**Minutes of the Regular Telephonic Meeting of the Albany County Airport Authority**

**April 6, 2020**

**11.1 Change Orders #5 & 6: Authorization to award Change Orders No. 5 & 6 to Contract No. 989-GCr New Parking Garage General Construction to LeChase Construction Services, LLC.**

4 CONTROL BOOTH GRADE LEVEL PLAN

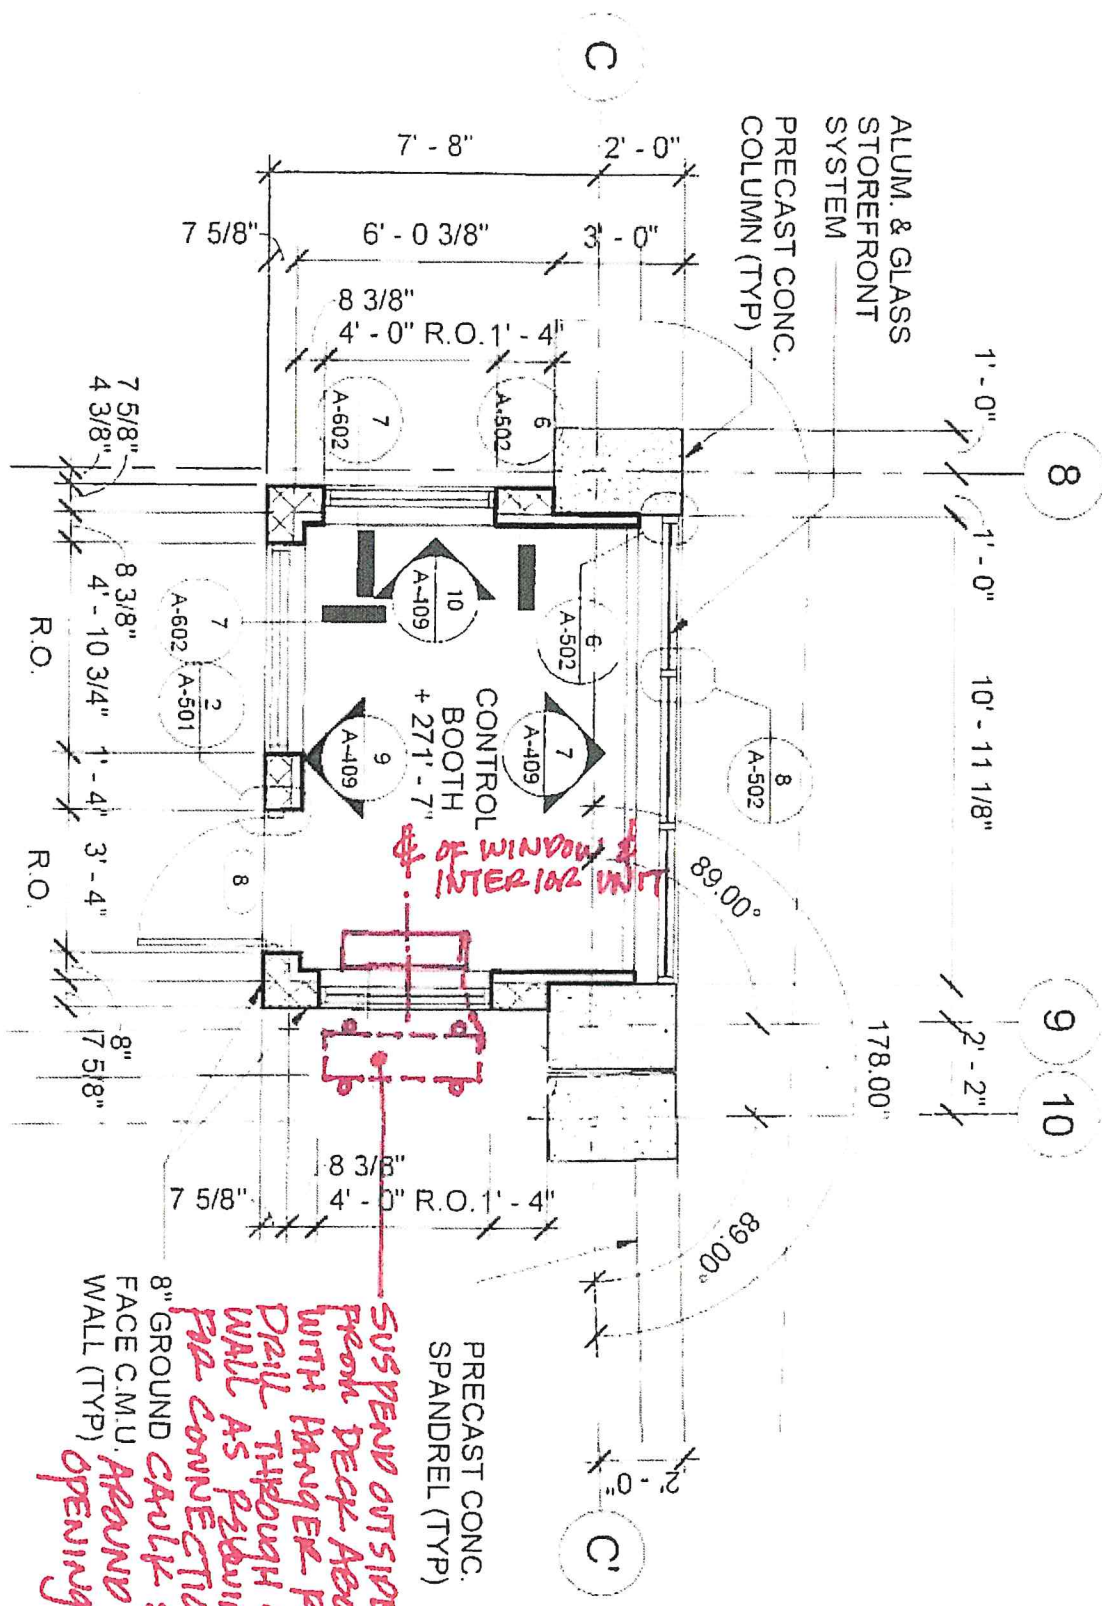
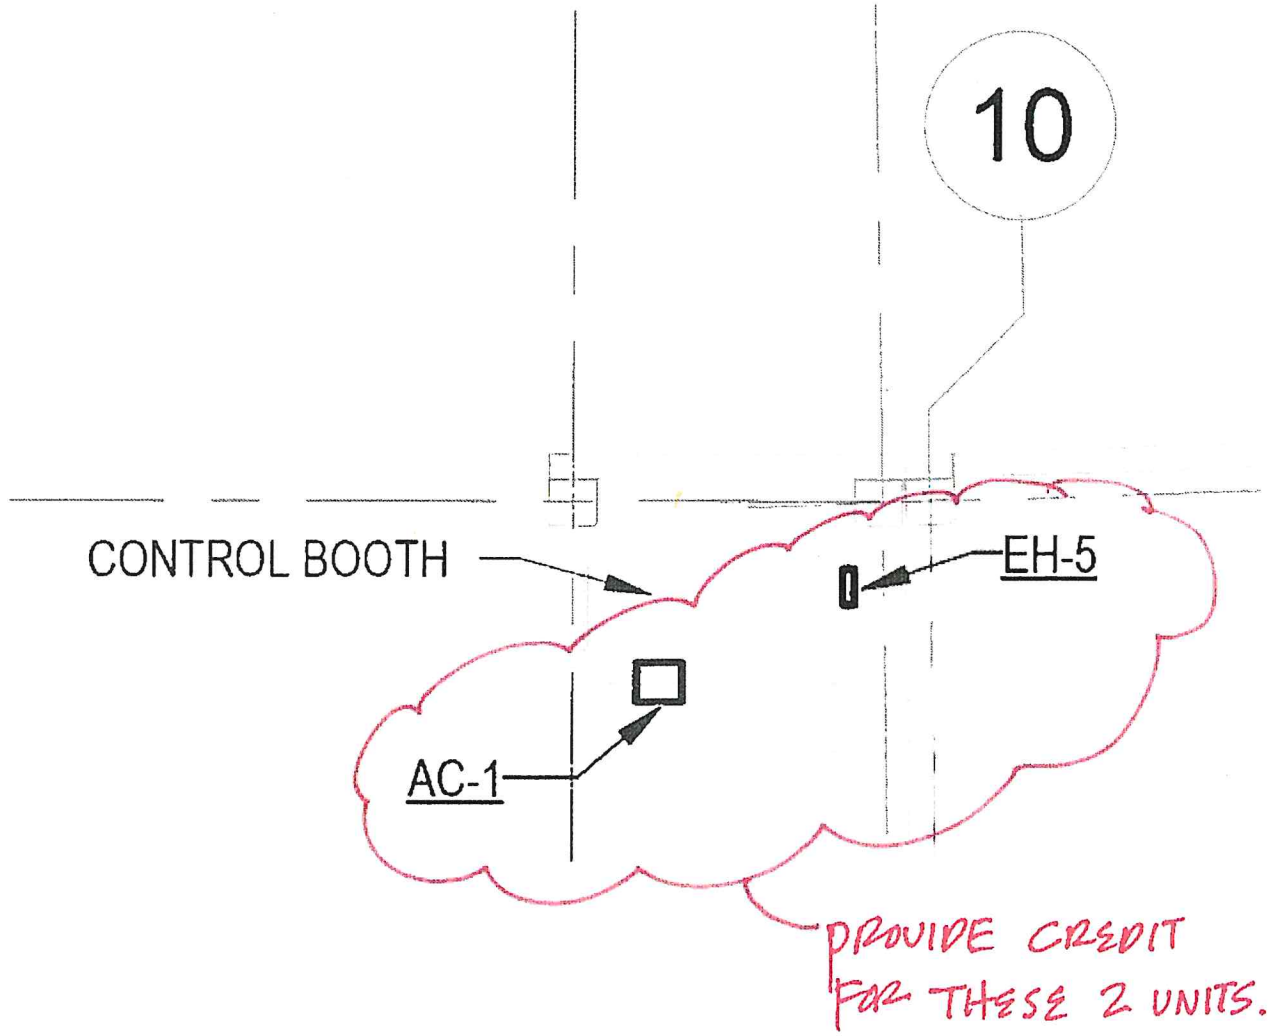
PROVIDE FRAME/MITSUBISHI ELECTRIC  
 SPLIT SYSTEM HEAT PUMP UNIT IN LIEU OF  
 SPECIFIED AC WINDOW UNIT. SEE ATTACHED  
 CUT SHEETS.

SUSPEND OUTSIDE UNIT FROM DECK ABOVE WITH HANGER POPS. DRILL THROUGH CMU WALL AS PROVIDED FOR CONNECTION & SEAL 8" GROUND CABLE & SEAL AROUND PIPE OPENING.

|  | ALBANY INTERNATIONAL AIRPORT PARKING<br>GARAGE GENERAL CONSTRUCTION |  | DATE: 12/02/19<br>SK-FP-005 |

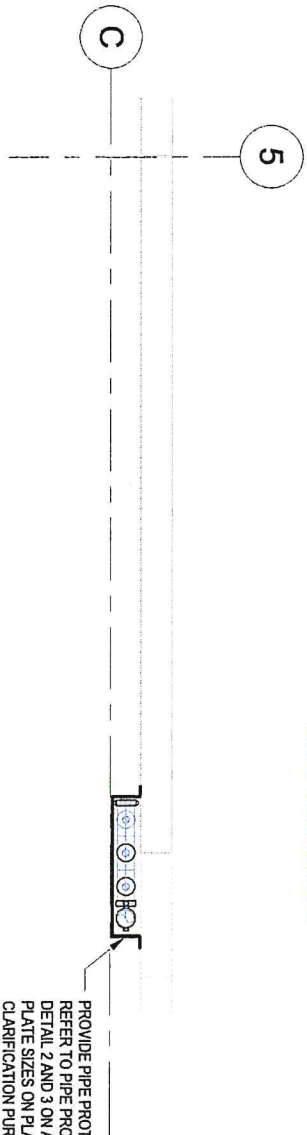
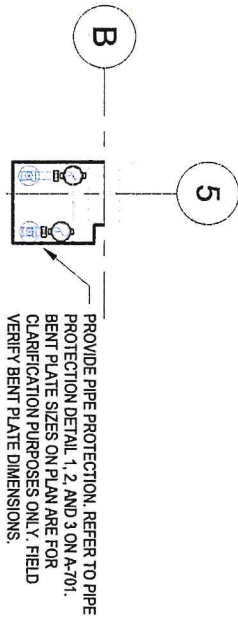
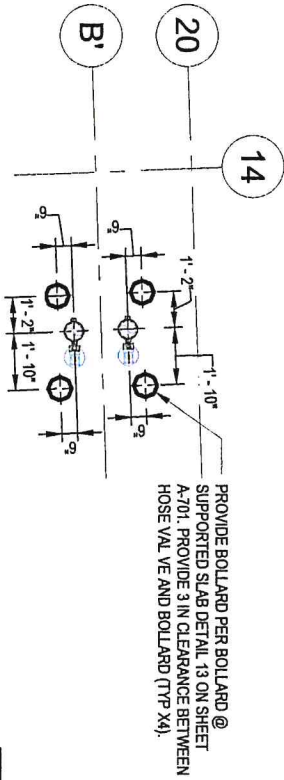
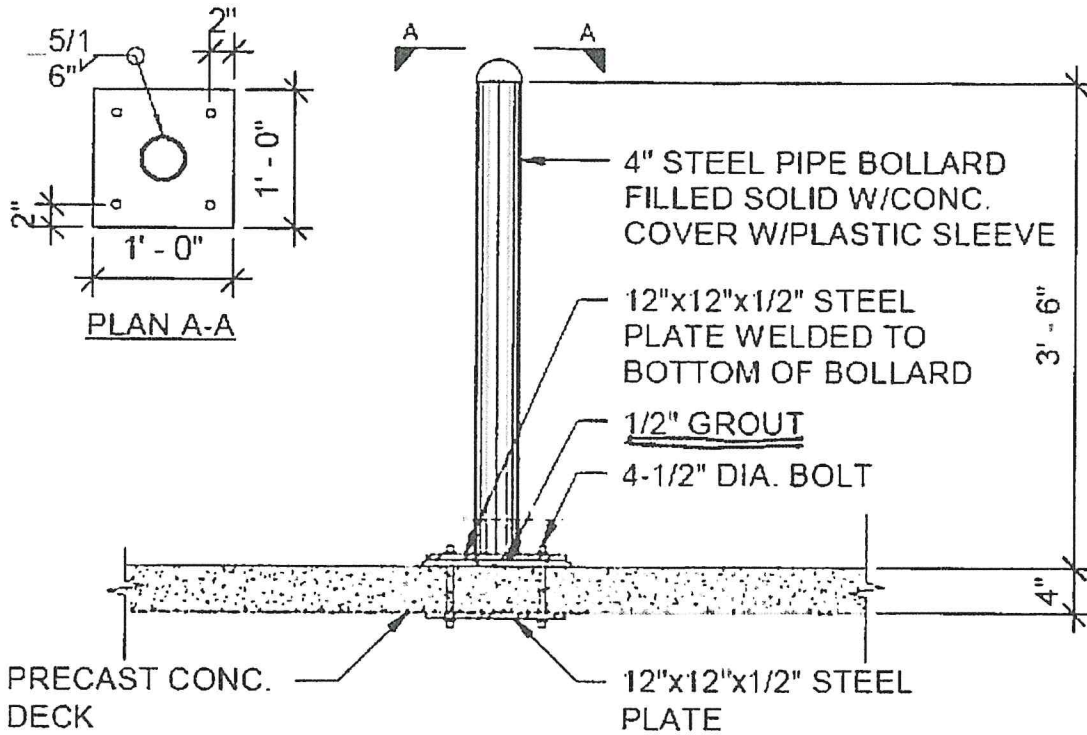
Provide bollard protection for free standing Standpipes on Level 5 (see attached plan and detail SK-FP-005 – Callout 3, along with standard bollard detail 13 / A-701).

PROVIDE PIPE PROTECTION, REFER TO PIPE PROTECTION DETAIL 2 AND 3 ON A-701. BENT PLATE SIZES ON PLAN ARE FOR CLARIFICATION PURPOSES ONLY. FIELD VERIFY BENT PLATE DIMENSIONS.

PROVIDE PIPE PROTECTION, REFER TO PIPE PROTECTION DETAIL 1, 2, AND 3 ON A-701. BENT PLATE SIZES ON PLAN ARE FOR CLARIFICATION PURPOSES ONLY. FIELD VERIFY BENT PLATE DIMENSIONS.

PROVIDE BOLLARD PER BOLLARD @ SUPPORTED SLAB DETAIL 13 ON SHEET A-701. PROVIDE 3 IN CLEARANCE BETWEEN HOSE VALVE AND BOLLARD (TYP X4).

LEVEL 5 FIRE PROTECTION VEHICLE IMPACT PROTECTION SKETCH

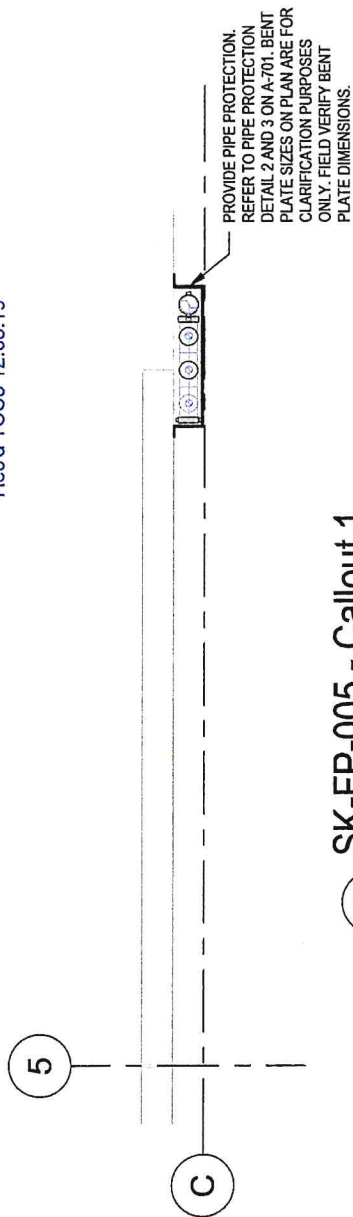
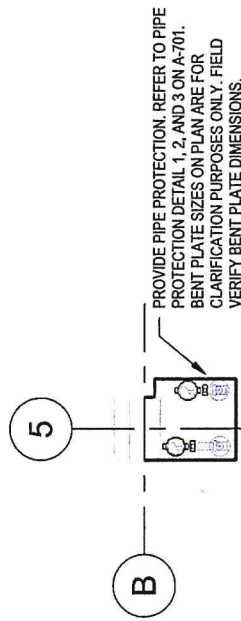
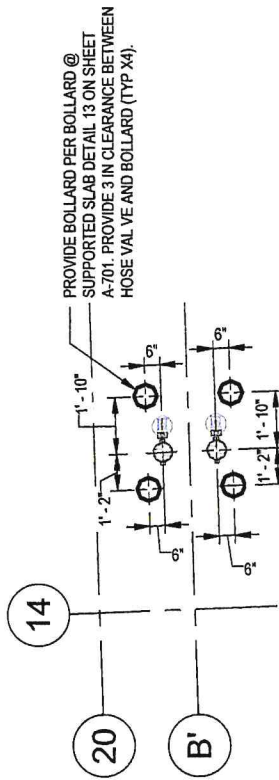
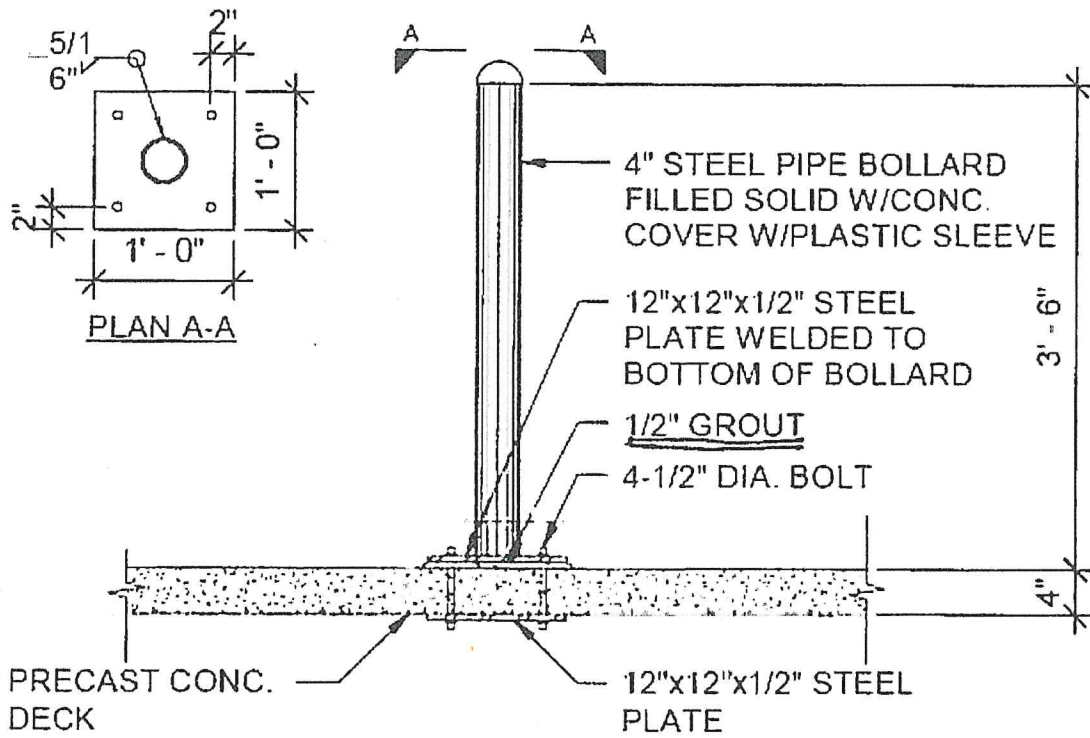
Provide bollard protection for free standing Standpipes on Level 5 (see attached plan and detail SK-FP-005 – Callout 3, along with standard bollard detail 13 / A-701).

1. STANDPIPE RISERS SHALL BE PROTECTED FROM MECHANICAL DAMAGE PER NFPA 14, SECTION 6.1.2.1. PROVIDE PIPE PROTECTION FOR EACH RISER ON ALL FLOORS. REFER TO DETAILS 1, 2, 3, AND 13 ON SHEET A-701 FOR PIPE PROTECTION REQUIREMENTS.
2. PROVIDE 3" MINIMUM CLEARANCE BETWEEN ANY ADJACENT OBJECT AND THE HANDLE OF THE VALVE PER NFPA 14 (2013) SECTION 4.7.5.

Figure 2. Additional sections of Vinyl Coated Chainlink Fence and per detail 16A.201. This is to be addressed in the contract.

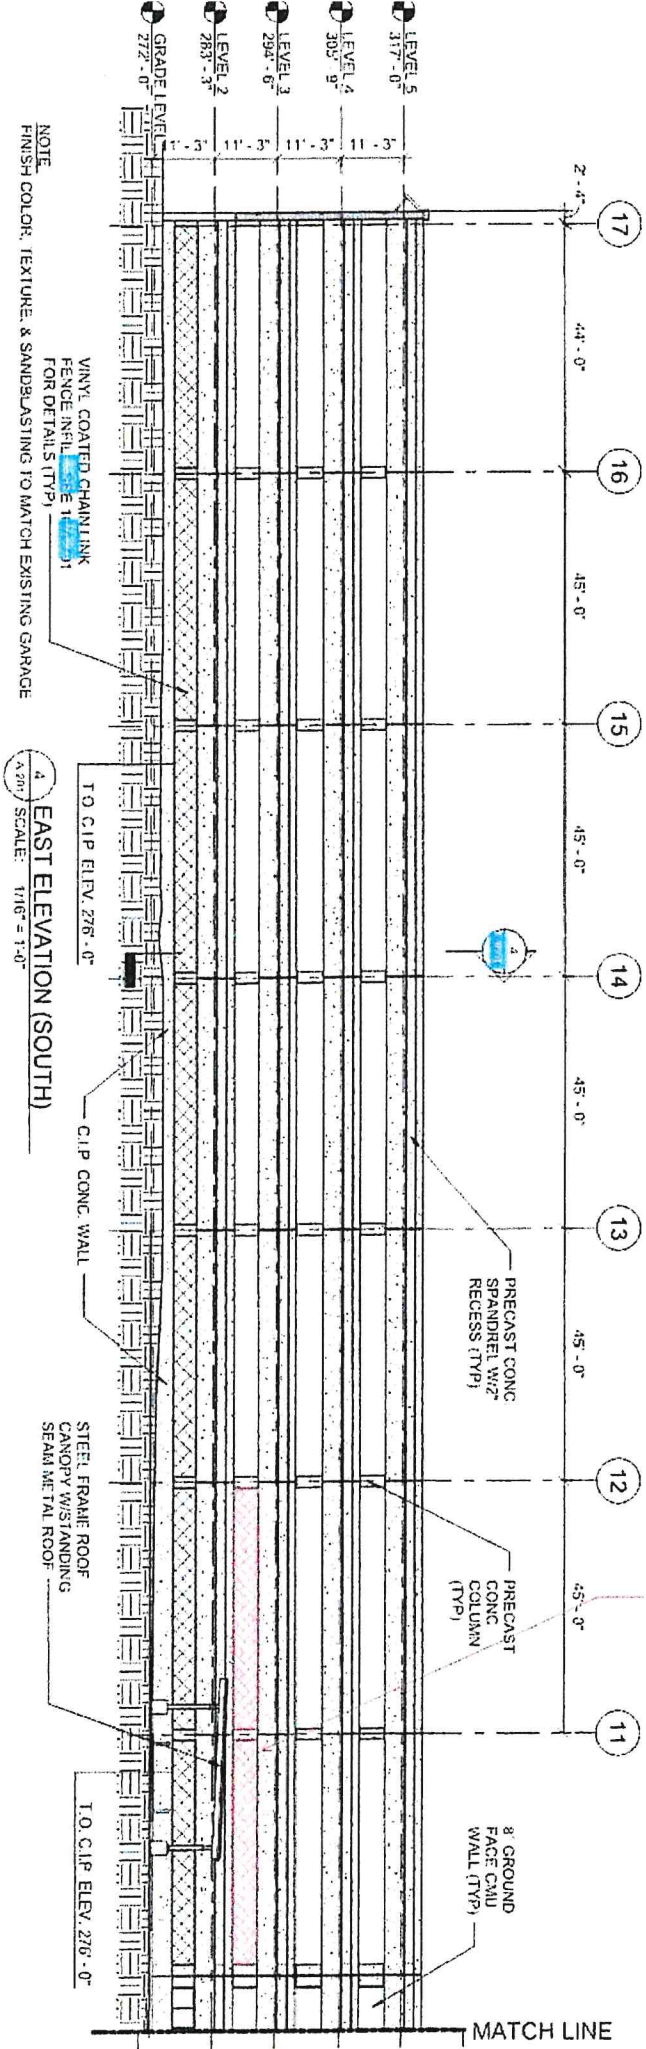
Provide the labor and material to install the vinyl coated chain link fence infill as indicated on A-201 detail 4. Refer to Detail 16 on A-701 for further information. Also, provide two additional sections on the second level as indicated on attached screenshot from A-201.
